August 14, 2020

ADDENDUM NO. 3

ASHLAND

**Federal Aid Project Nos. CMQ-003S(390), STP-003S(390) & TAP-003S(390)
Roadway Reconstruction and Related Work along Route 126 (Pond Street)**

ADDENDUM NO. 2 - SKETCH 1
ASHLAND, MA
604123 - ROUTE 126 (POND STREET)
CMQ/TAP/STP-003S(390)

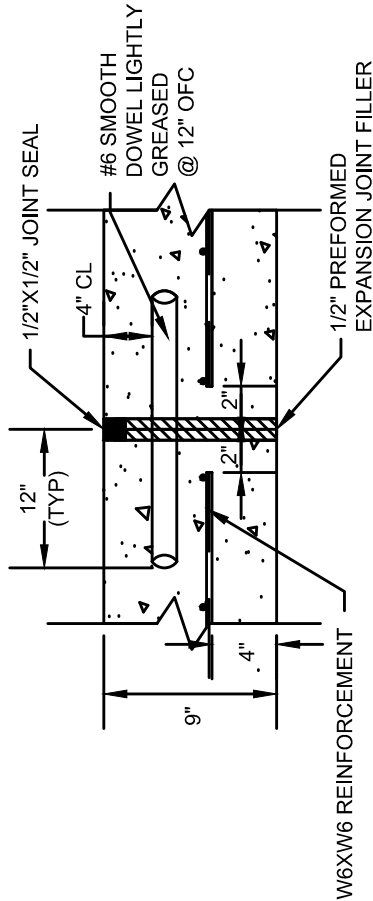
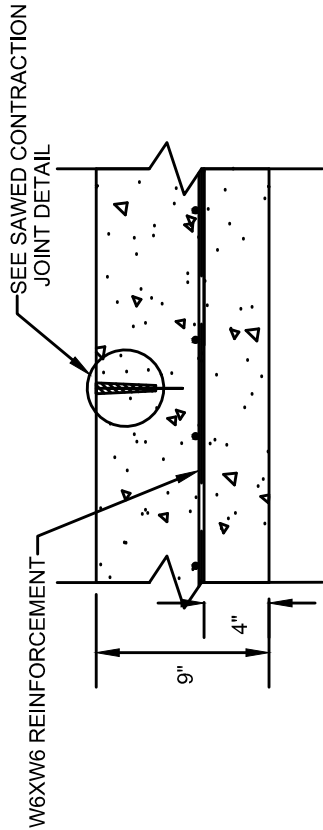
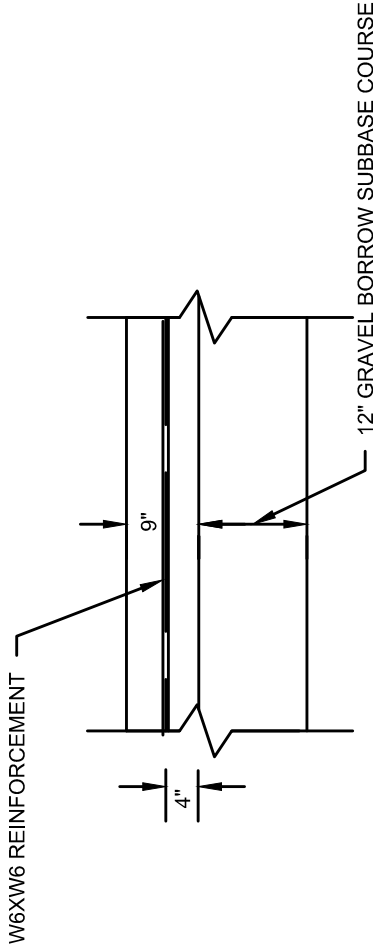
Question #6: Sheet 192 Roundabout Apron Detail

Please provide a detail of the expansion and contraction joints, including smooth dowels bars and preformed joint filler.

Please provide clarification of the 12"x12" slate stone, 12" wide patterned accent strips.

Response #6: See new Document A00803 and revised page A00801-105.

- ③ The 12"x12" slate stone band is a band with a different stamp pattern that is comprised of 12"x12" squares textured to look like stone. The field will be a running bond brick stamp pattern as stated in the special provision. The 12" by 12" slate stone band shall be placed at one edge of all visible joints as shown on the drawing. Note that all colored stamped concrete will be red brick color. The slate stone band is part of the same pour as the adjacent brick pattern.
